**CN Milton Logistics Hub – Project Changes
Report (Multiple Changes)**

File: 160901330

This report has been prepared to describe a series of proposed changes resulting from refinements made during the detailed design of the proposed terminal components. Section 2.0 provides a description of the proposed Project changes, including:

CN MILTON LOGISTICS HUB - HALTON SUBDIVISION - PHASE 3 TERMINAL STORMWATER MANAGEMENT PLAN SHEET 1 OF 3											
PROJECT NUMBER				DRAWING NUMBER				ISSUE/REVISION			
60579933				04-C-1007				0

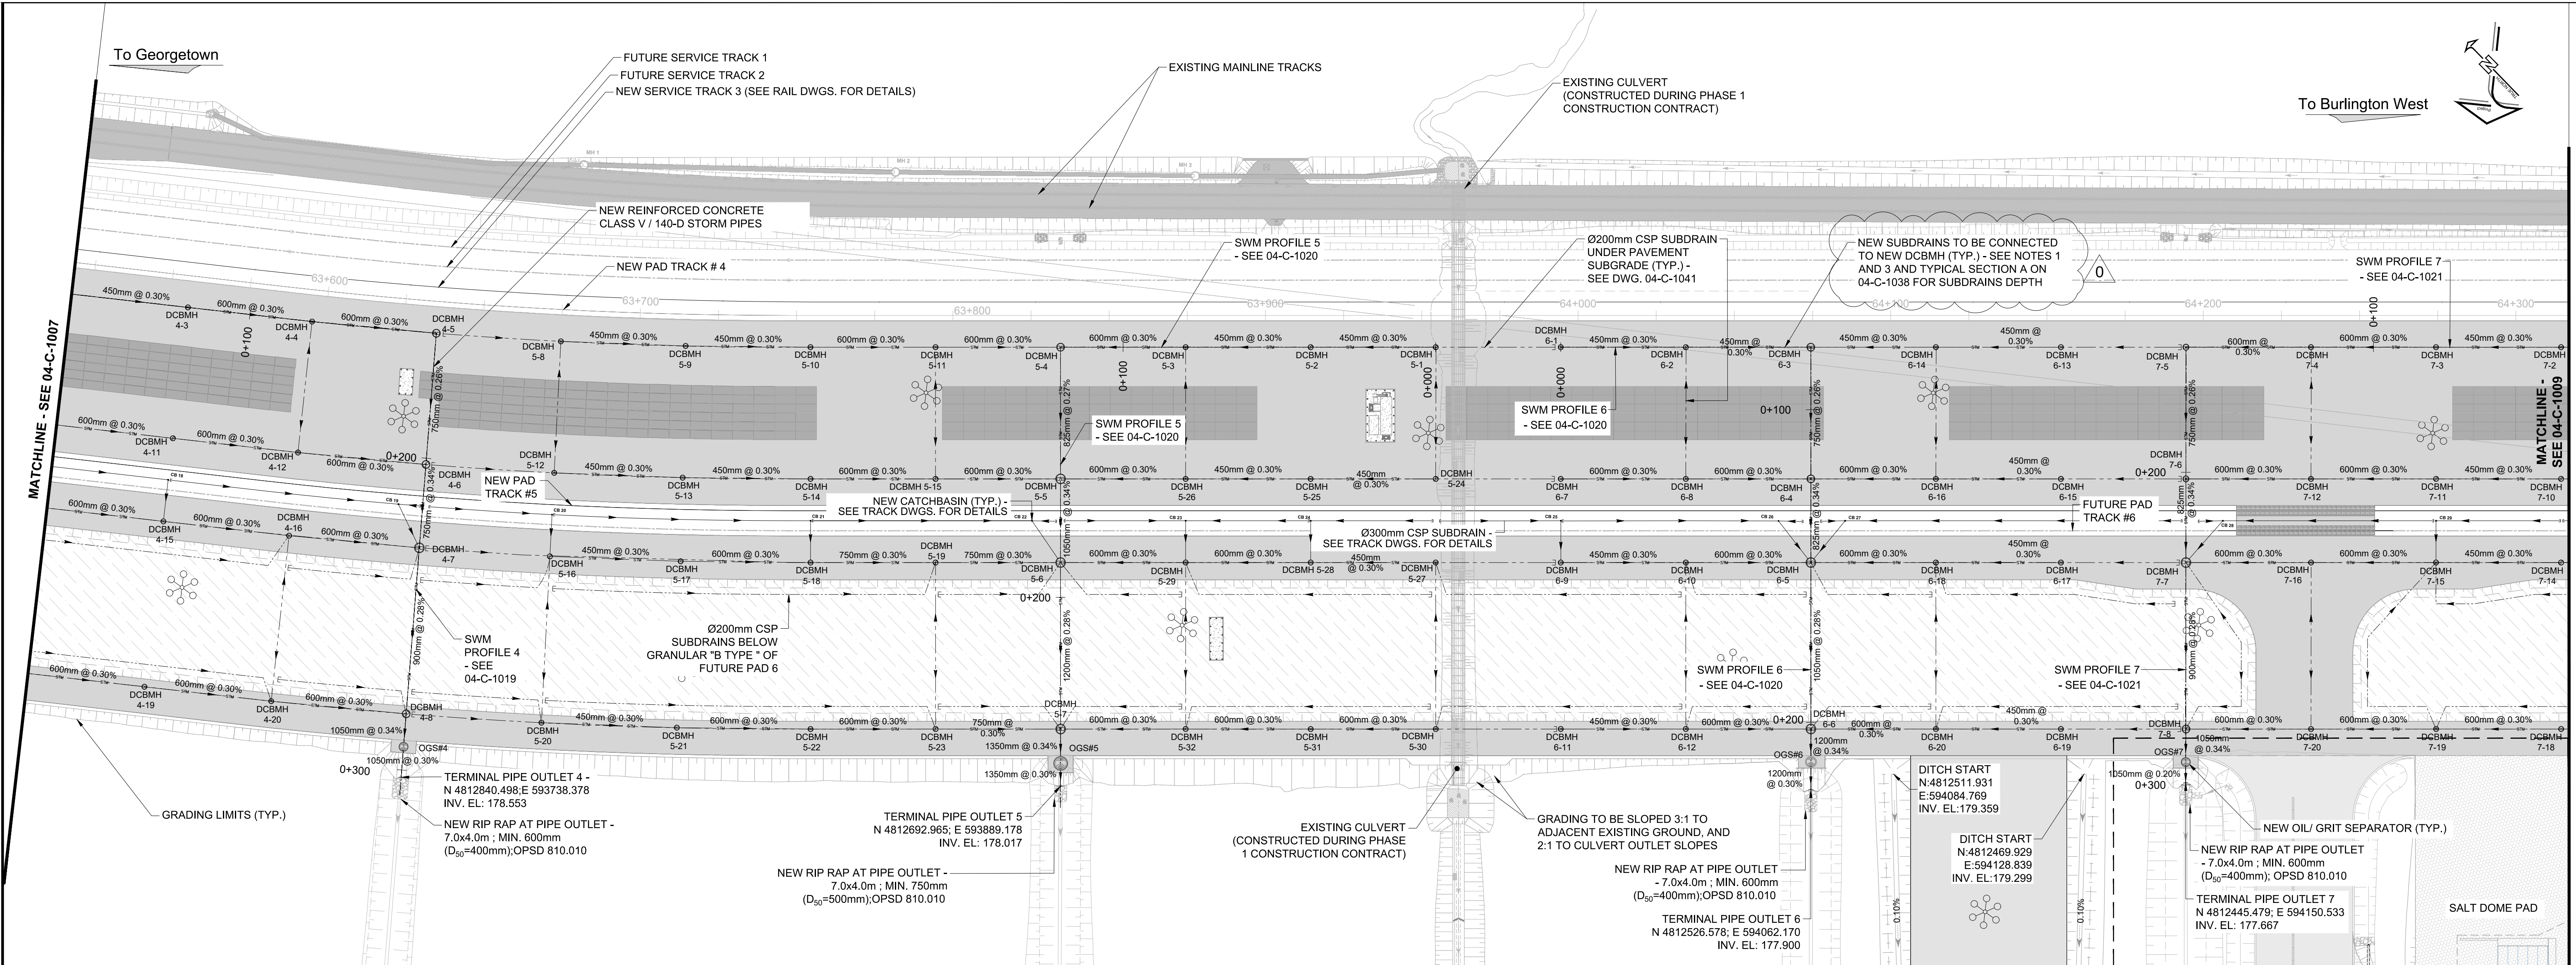
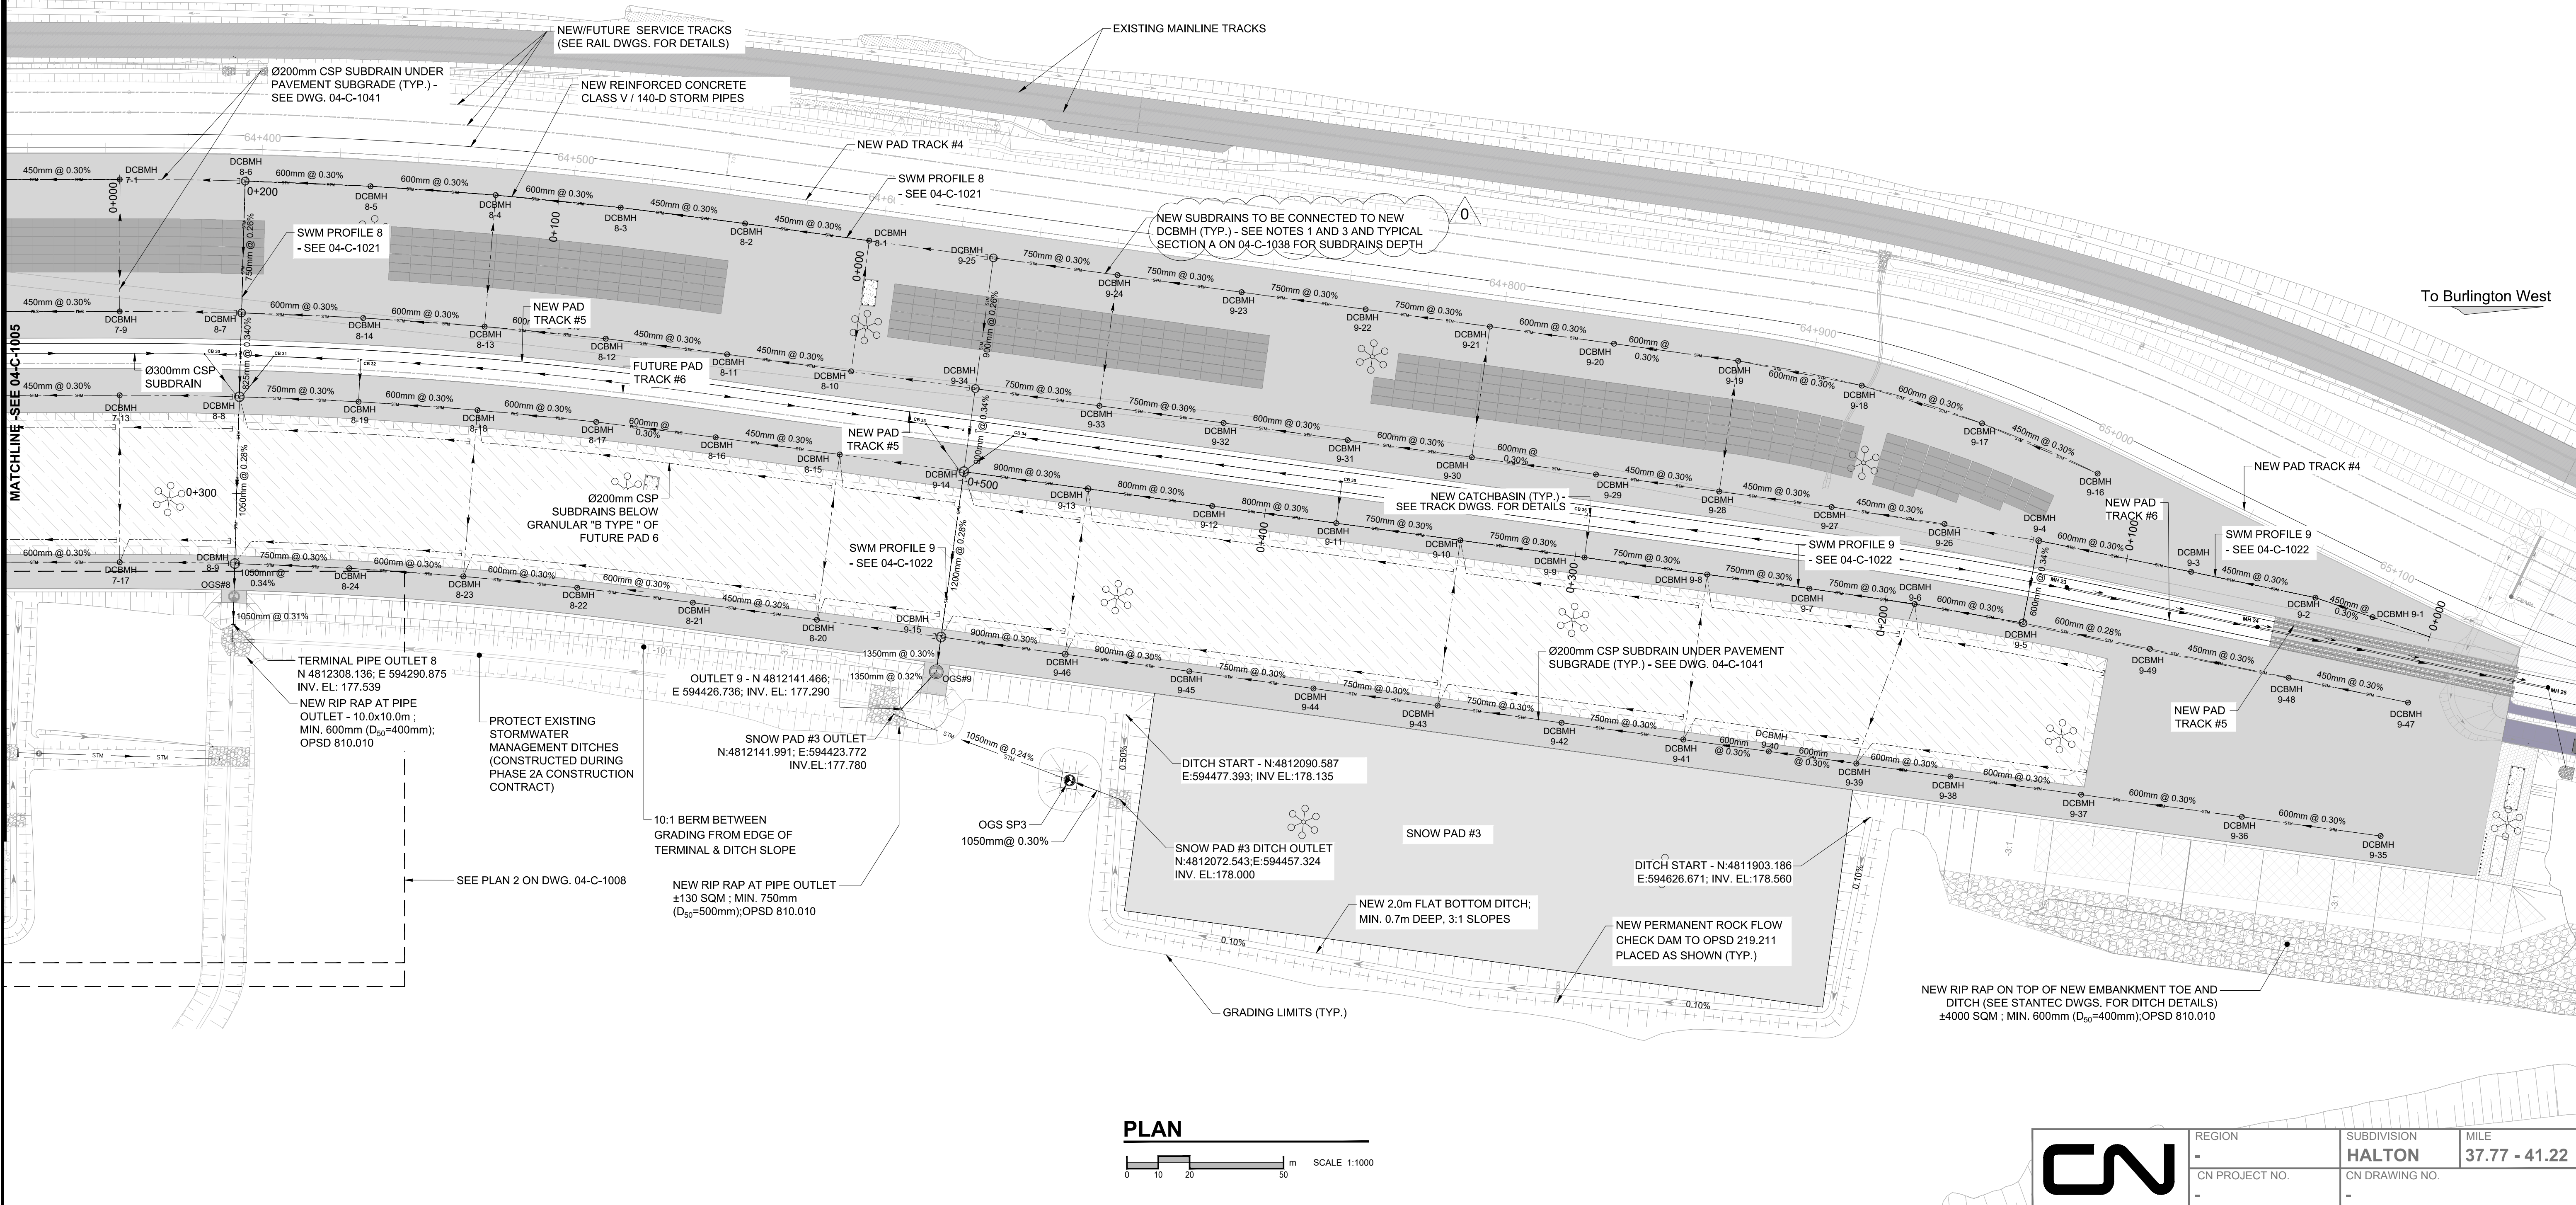
Based on this assessment, portions of previously approved work pads are proposed to be expanded to accommodate snow storage through the creation of three defined snow storage areas adjacent to the workpads. The proposed snow storage pads would consist of paved extensions of the existing work pads within the PDA, and include:

Each pad area would be surrounded by ditches designed to collect and convey meltwater and runoff to either Stormwater Management (SWM) Pond 1 or 2. The general locations of the proposed snow storage pads are shown on Figure 1 in Appendix A, with additional details provided in Appendix C.

The proposed salt storage facility would consist of a covered salt dome constructed on an impermeable pad, located within a previously identified temporary construction laydown area east of the administration building and maintenance garage. The facility would be surrounded by ditches designed to collect and convey runoff to SWM Pond 2.

The location of the proposed salt storage facility is shown in Figure 1 in Appendix A, and illustrated on the engineering drawings in Appendix C.

**Temporary and Permanent
Restricted Areas for Natural
Features (Update)**

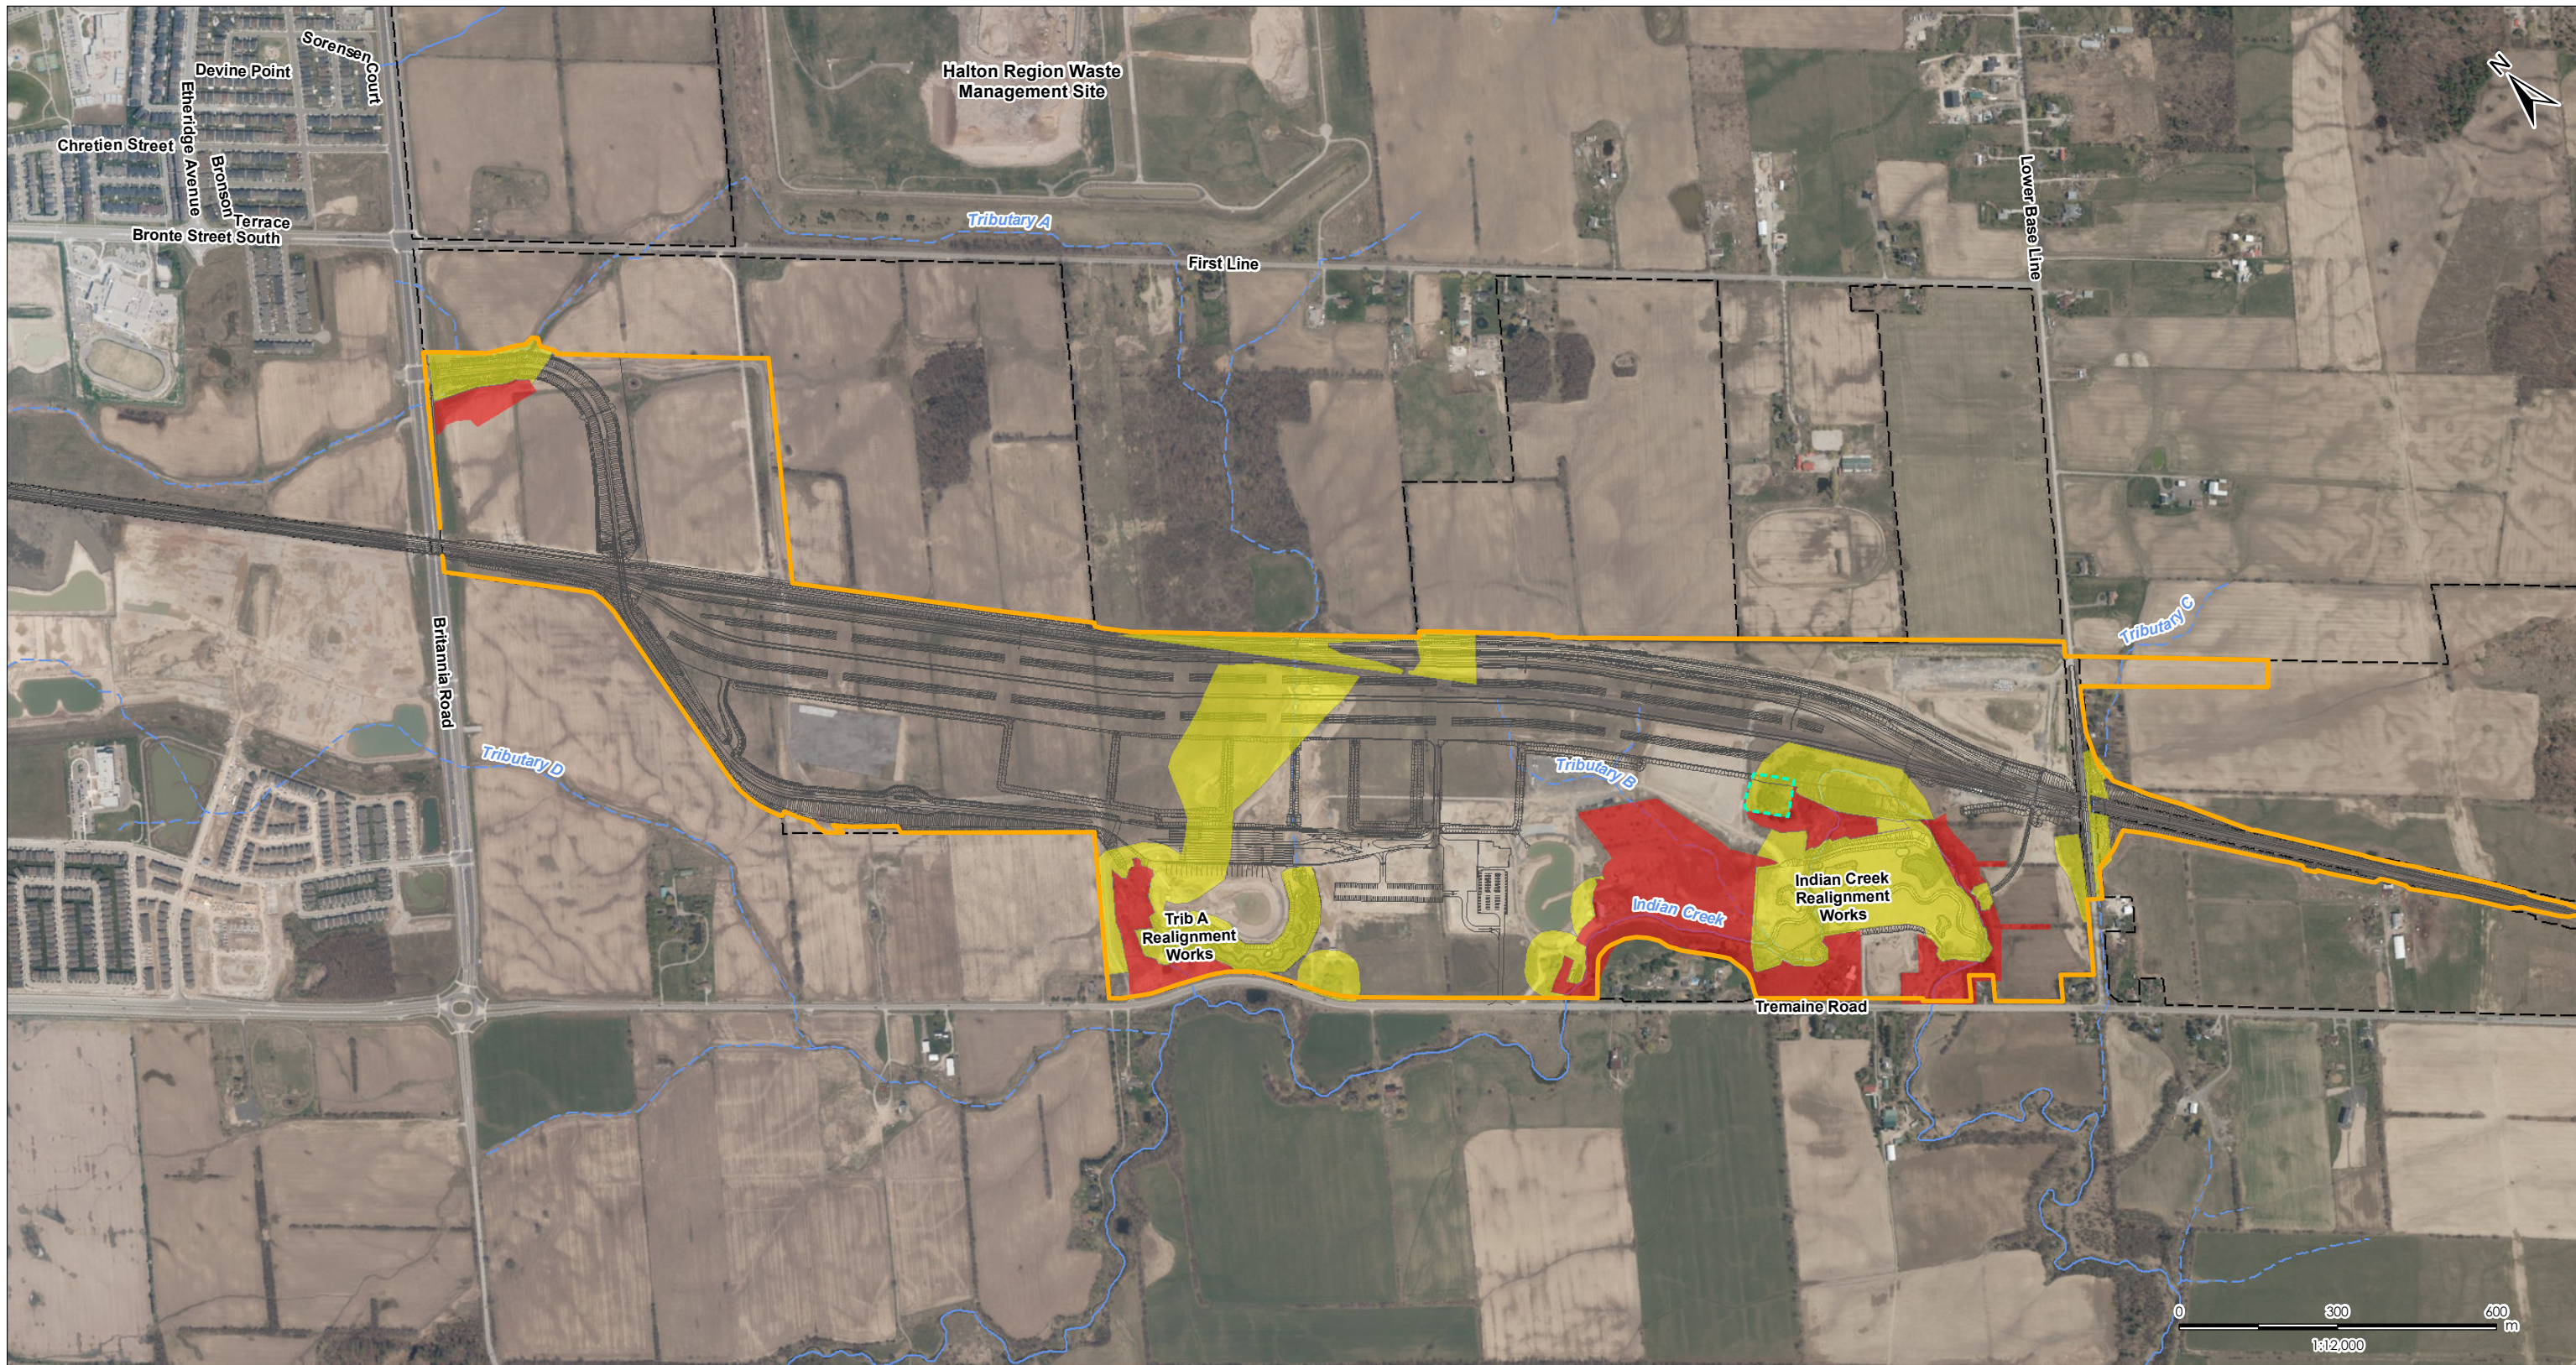
Subsequent to the EIS, and in support of the identification of buffers and setbacks required in accordance with Condition 6.4, this plantation was identified as a feature where construction activities were prohibited since this feature was initially being avoided as part of the detailed construction plans. However, the proposed

change will require encroachment into this feature and the buffer recommendations were adjusted accordingly (see Appendix D for the updated figure). Implementation of the proposed Snow Storage Pad 3 will require limited disturbance within buffer of undisturbed vegetation established around retained wetlands and riparian areas, as required under Decision Statement Condition 6.4. See the figures in Appendix A and Appendix D for details. This disturbance is necessary to meet engineering and operational requirements for safe railway and facility operation, consistent with Condition 6.4.2, which permits work within buffers for such purposes.
